PERMIT MODIFICATION APPROVAL

Re: Permit Modification Approval for API Number 103295 , Well #: AUD5BHS

Extend lateral

RE: **AUD5BHS - API# 47-001-03295 (Lateral Extension – extending 2840' more)**
AUD5CHS - API# 47-001-03296 (Lateral Extension – extending 2575' more)
AUD5DHS - API# 47-001-03294 (Lateral Extension – extending 2890' more)
AUD5EHS - API# 47-001-03293 (Lateral Extension – extending 2480' more)

Casing Schematic

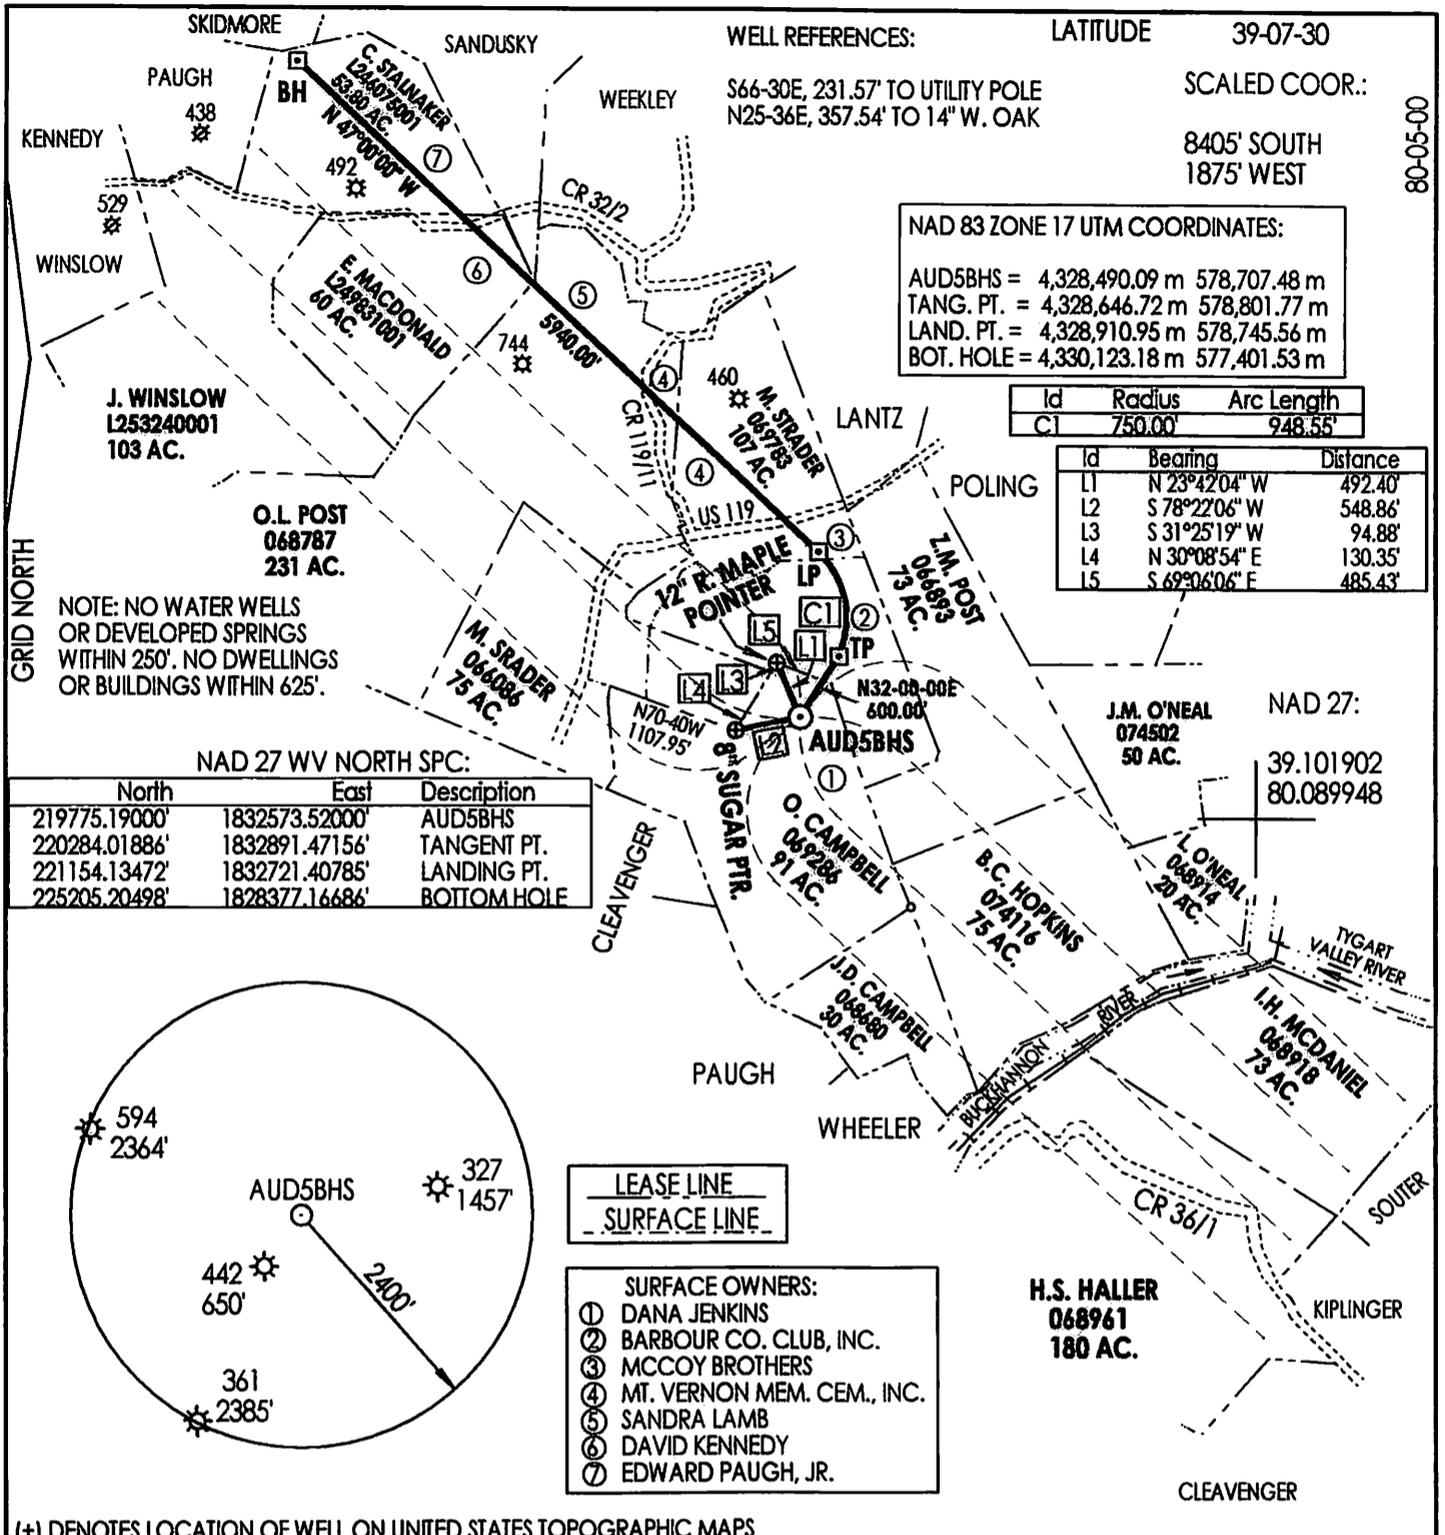
Enclosed, please find, per your request, clarification of the TVD, TMD, formation at TVD, and the cement section on the WW-6B for the modifications sent to you and dated December 4, 2014 for the AUD5BHS-AUD5EHS to extend the laterals due to additional leasing being obtained. I have attached updated casing plans, casing schematics, and mylar plats reflecting these changes.

DATE: FEBRUARY 11, 2015
 OPERATORS WELL NO.: AUD5BHS
 API WELL NO. 47-001-03295 MOD
 STATE WV COUNTY BARBOUR PERMIT

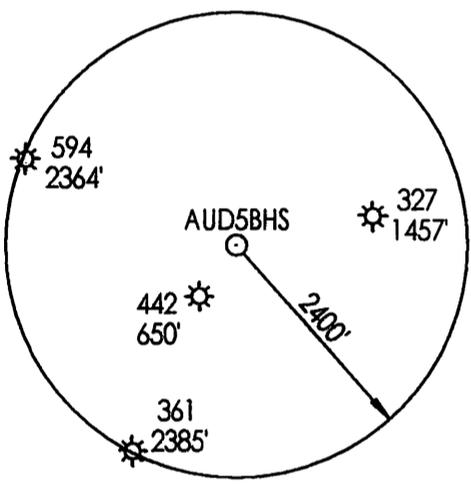
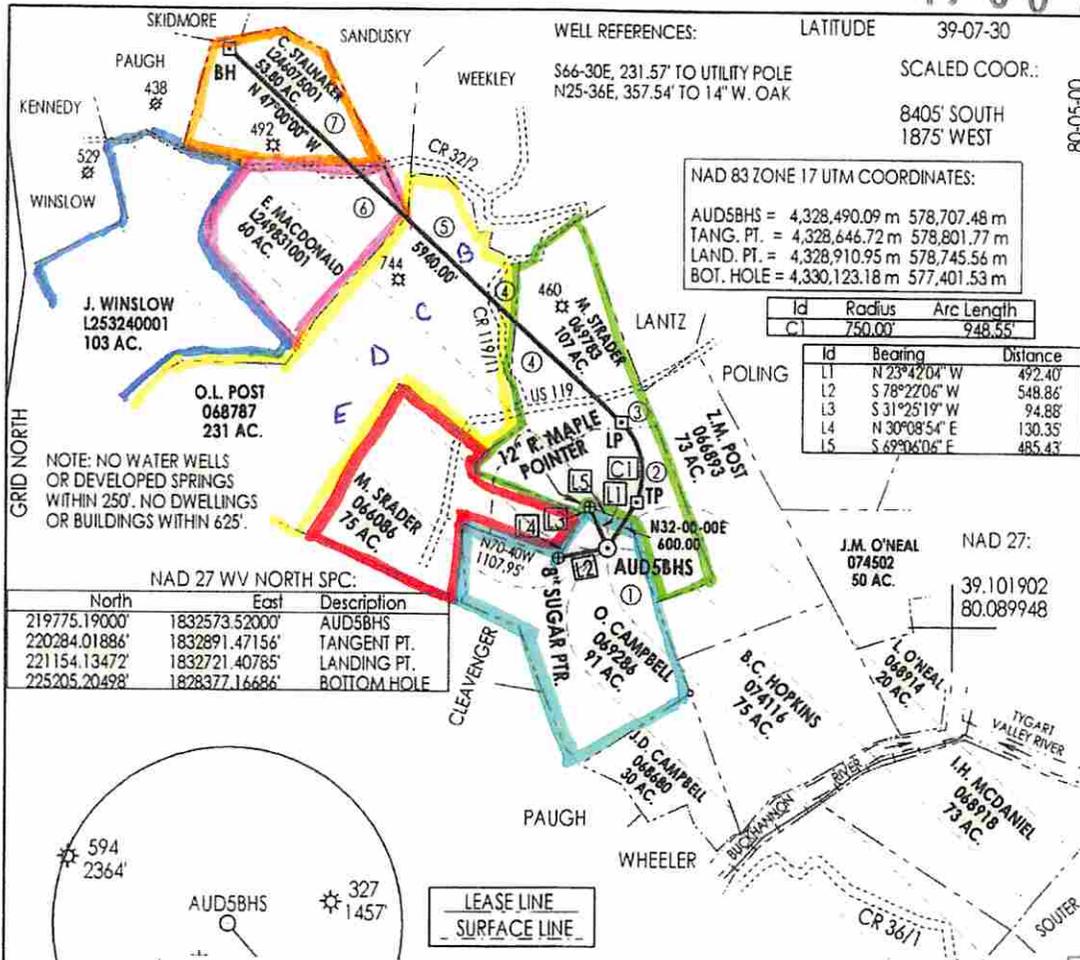
Enclosed, please find modifications for the AUD5BHS-AUD5EHS to extend the laterals due to additional leasing being obtained. I have attached an updated casing plan, mylar plat, lease breakdown, and road letters where applicable.

TARGET FORMATION MARCELLUS PLUG & ABANDON CLEAN OUT & REPLUG
 ESTIMATED DEPTH TVD = 7670' TMD = 15159'
